**CITY OF EAST PALO ALTO, CALIFORNIA
DEPARTMENT OF PUBLIC WORKS – ENGINEERING DIVISION**

ADDENDUM No. 5

**US 101 / UNIVERSITY AVENUE INTERCHANGE IMPROVEMENTS
CIP-ST-14**

Date: 03/07/2023

DETOUR PLAN No. 3
FROM SB 101 TO UNIVERSITY AVE

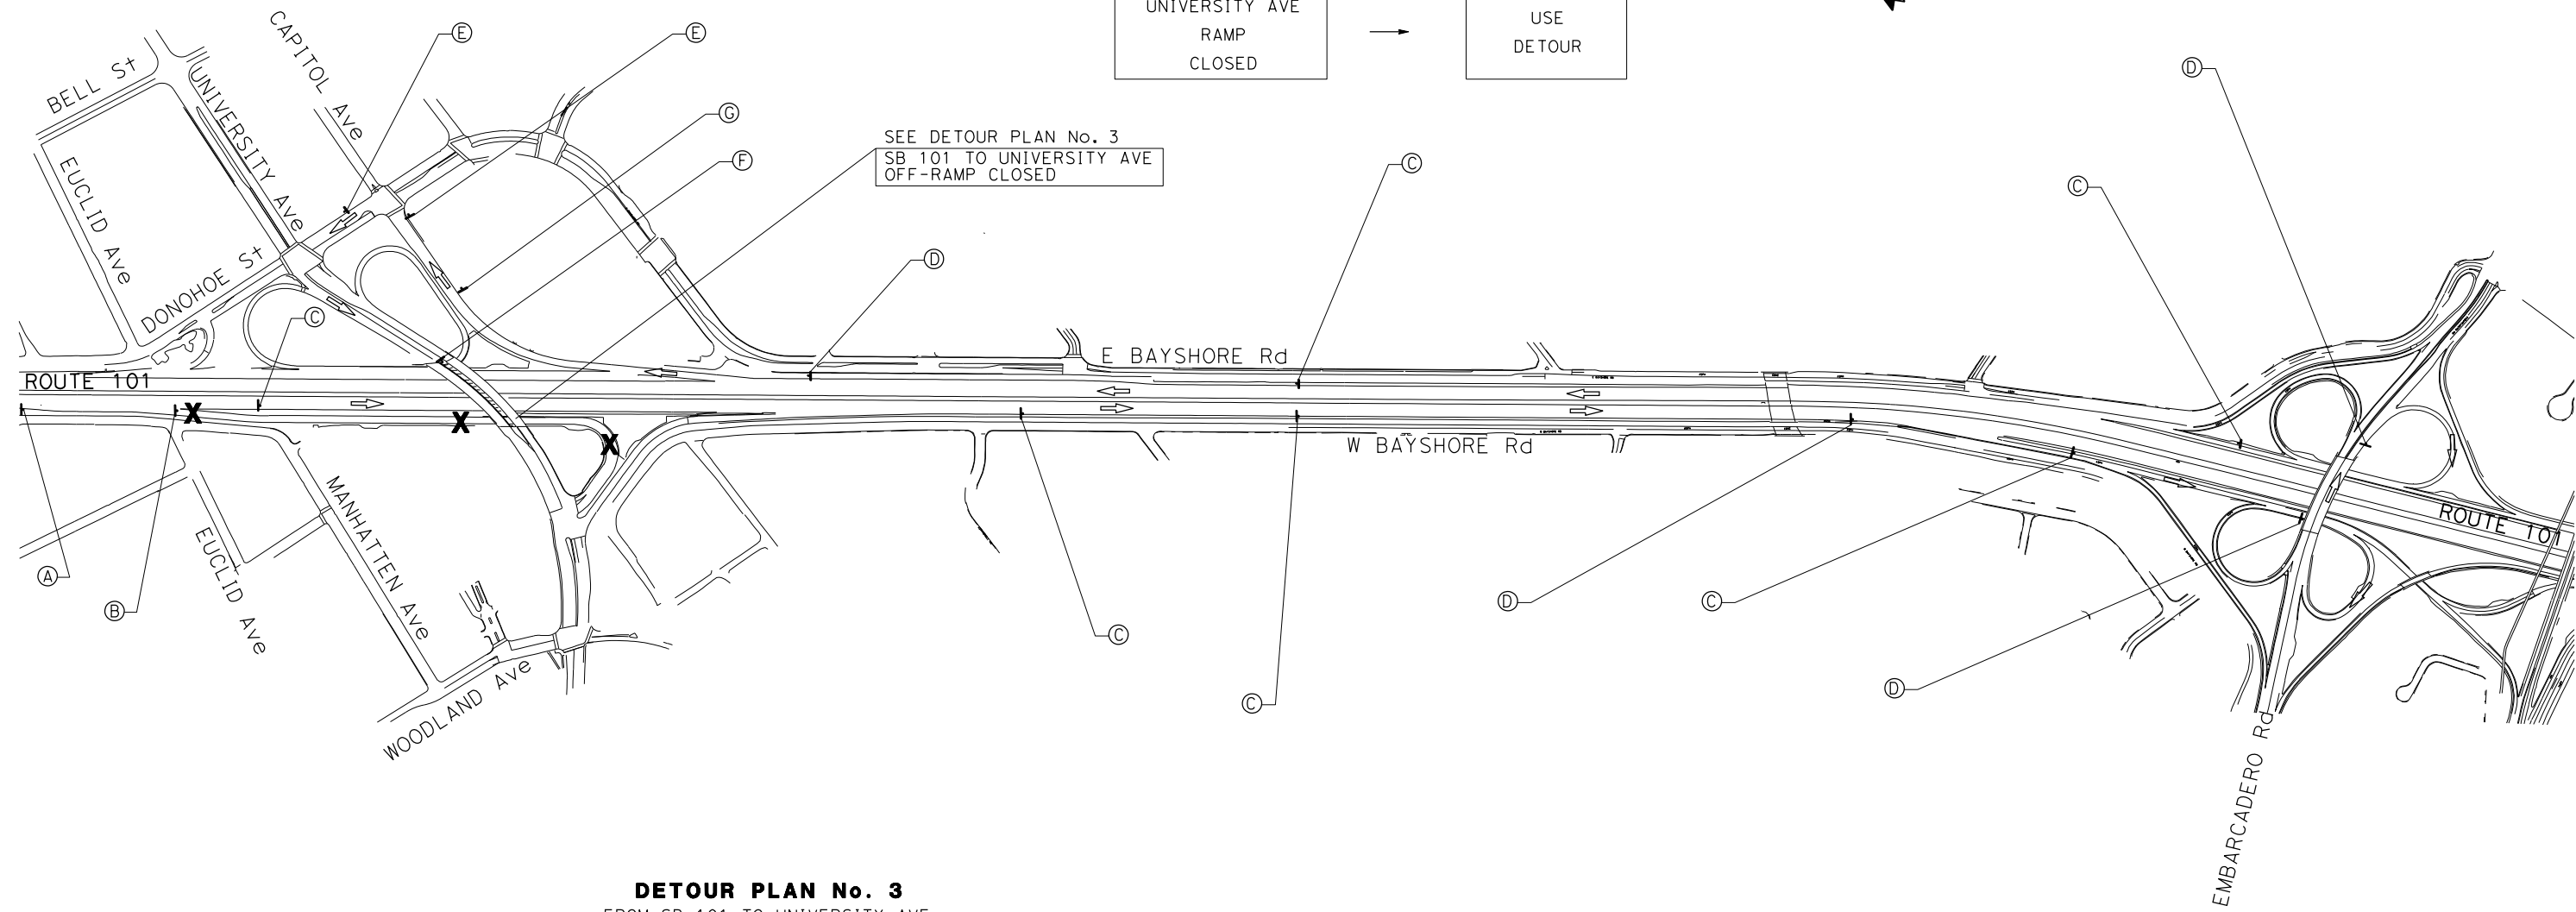
1. After plan sheet 43 of 136, “Motorist Information Plan M-2,” replace plan sheet 44 of 136, “Motorist information Plan MI –” and attached plan sheet 45 of 136, “Motorist Information Plan MI -” with attached plan sheet “Motorist Information Plan MI-3” and plan sheet “Motorist Information Plan MI-4,” respectively.
2. Replace plan sheet 75 of 136, “Irrigation Sprinkler Schedule ISS-1” with the attached plan sheet having the same name.
3. Replace plan sheet 79 of 136, “Plan Legend PL-1” with the attached plan sheet having the same name.
